**DRAFT ENVIRONMENTAL IMPACT STATEMENT FOR THE
COMPREHENSIVE DESIGN PLAN FOR THE WHITE HOUSE AND
PRESIDENT'S PARK**

Comments to the National Park Service

March 4, 1999

Belowground
Alternative 2

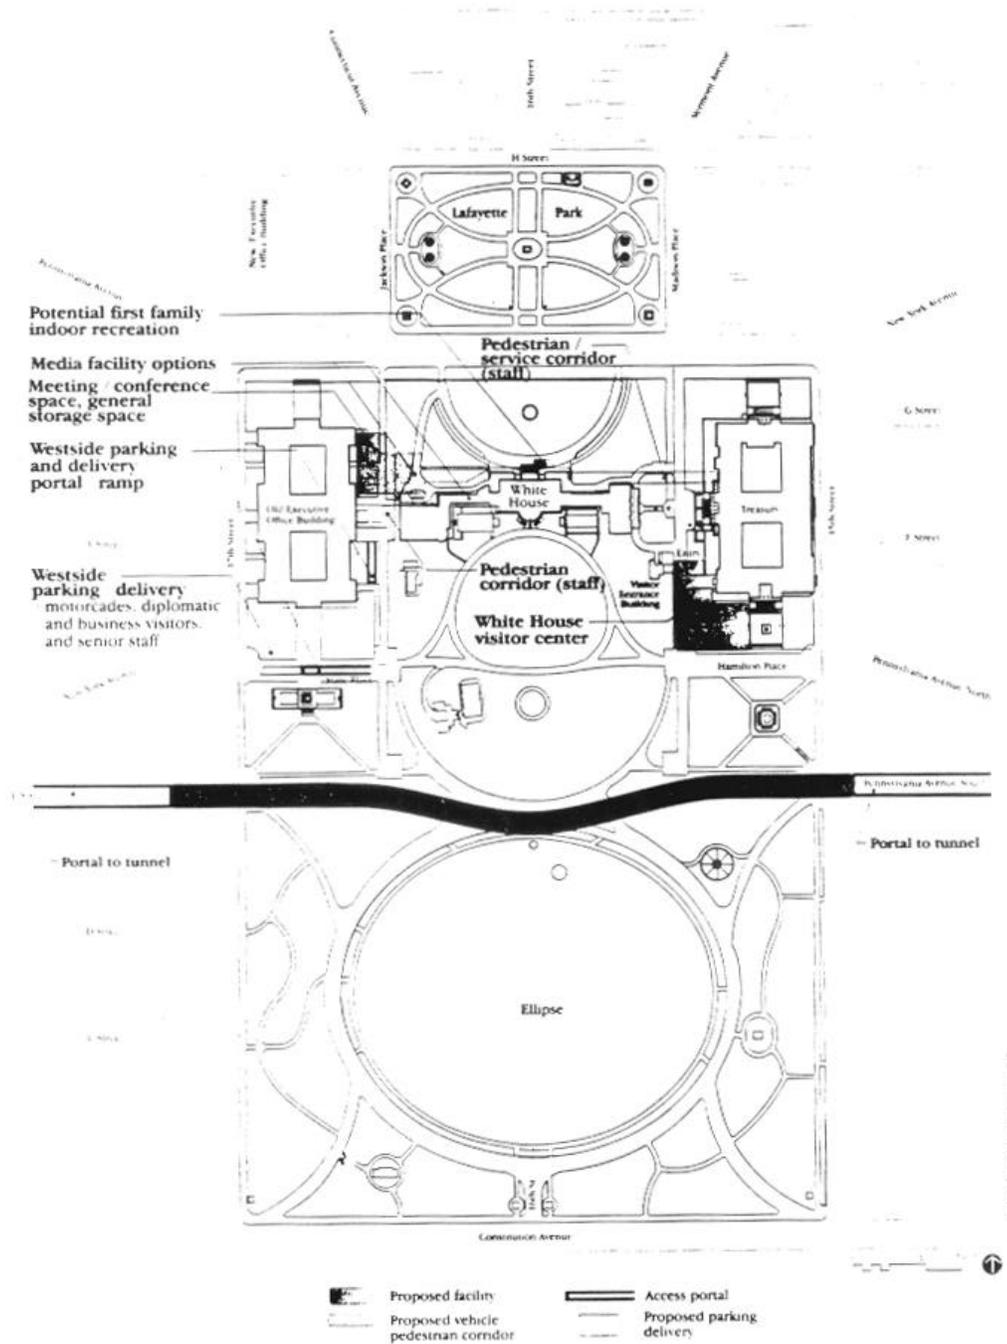
We note that Alternative 2 proposes a tunnel under E Street for vehicular traffic. We recommend against implementation of the tunnel. In the absence of other alternatives at present, the tunnel denies the drive-by experience so valued by all visitors to and residents of the Nation's Capital.
